NAVAL AIR WARFARE CENTER AIRCRAFT DIVISION

Subj: SUPPORT EQUIPMENT BULLETIN NO. 708, TD CODE 63, MOBILE FACILITY, AIR CONDITIONER PANEL

a. DWG NO	TITLE	REV	CAGE
1339AS775	PANEL, AIR CONDITIONER MOBILE FACILITY	D	30003

FIG 1

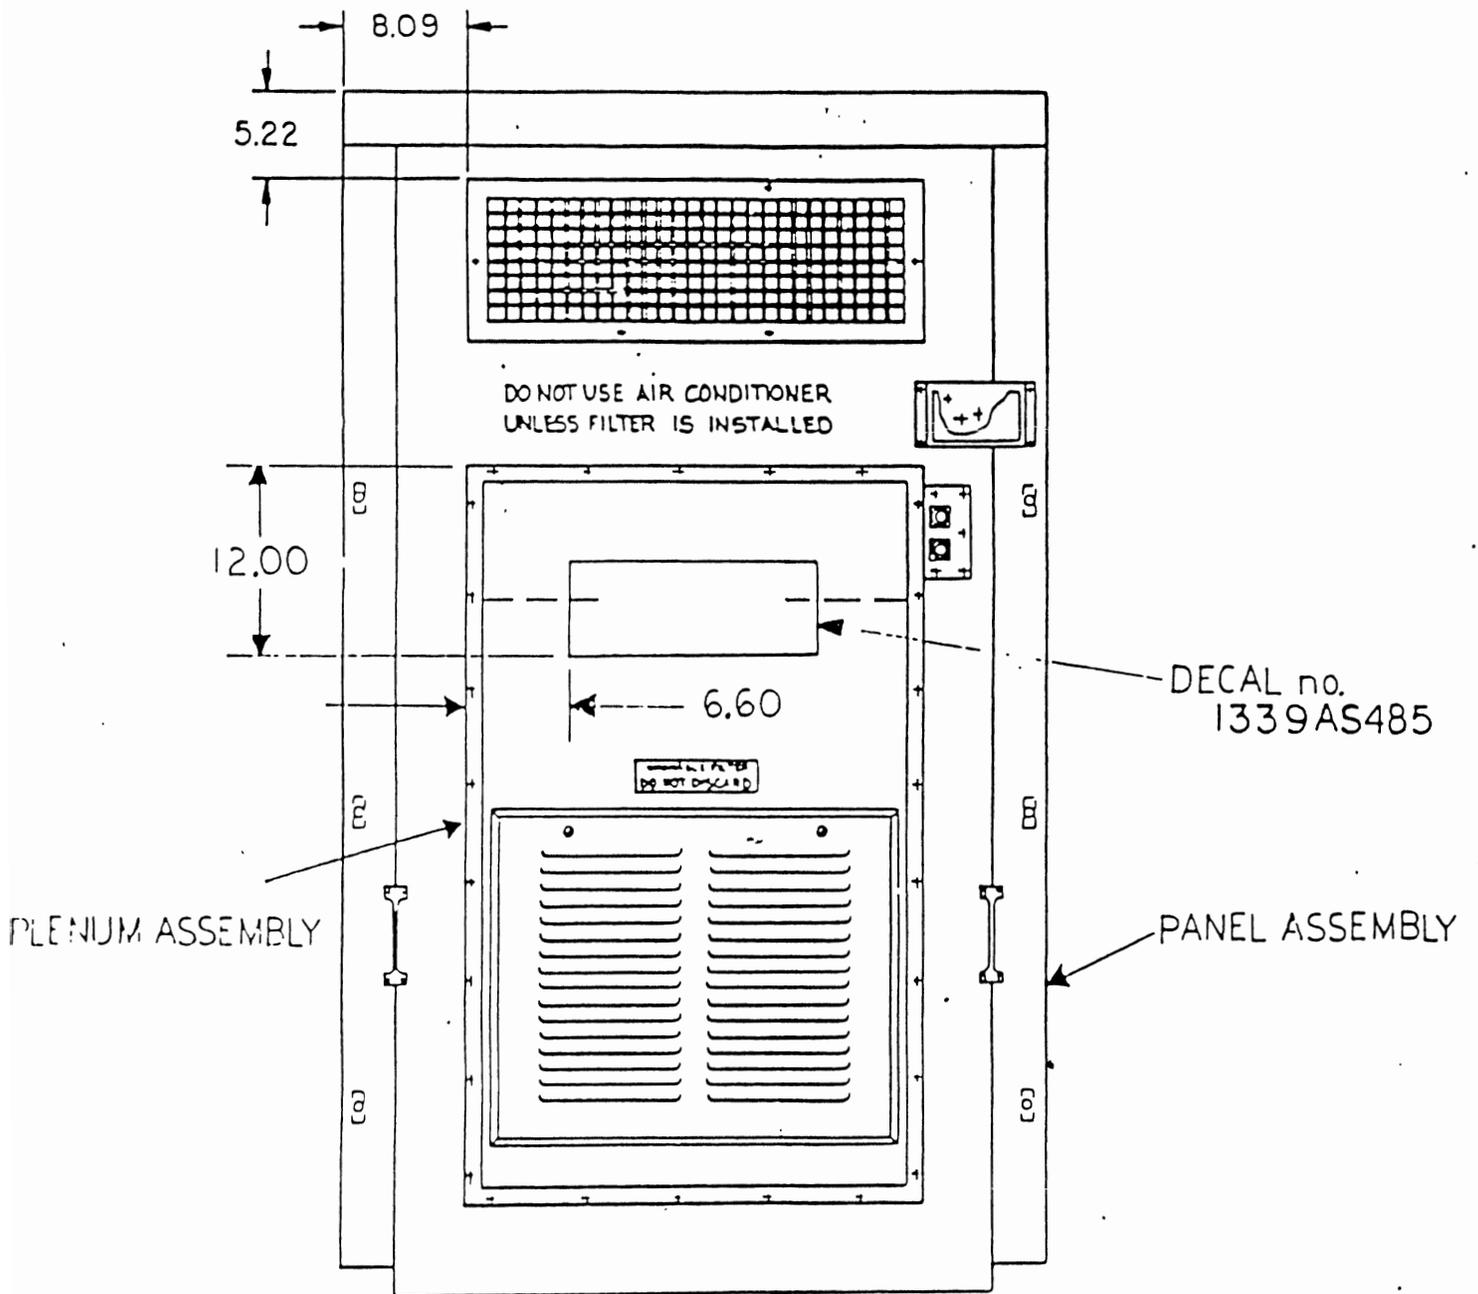
a. Locate the air conditioner panel on the side of the mobile facility. Make sure there is no dirt, dust, grease, oils or any other foreign material on the surface of the panel assembly (see fig. 1). Make sure the paint is in good condition, not flaking or peeling, so that the decal has proper adherence.

b. Peel the back of the decal to expose the adhesive. Be sure that the decal is not up-side-down. Place the decal on the plenum assembly panel with the decal's lower left corner 12 inches down from the top left corner of the plenum assembly panel, and 6.6 inches to the right of the plenum assembly panel's left edge (see figure 1 for an illustration). This should place

the decal at the center of the available space on the plenum assembly panel, if this is not the case adjust accordingly.
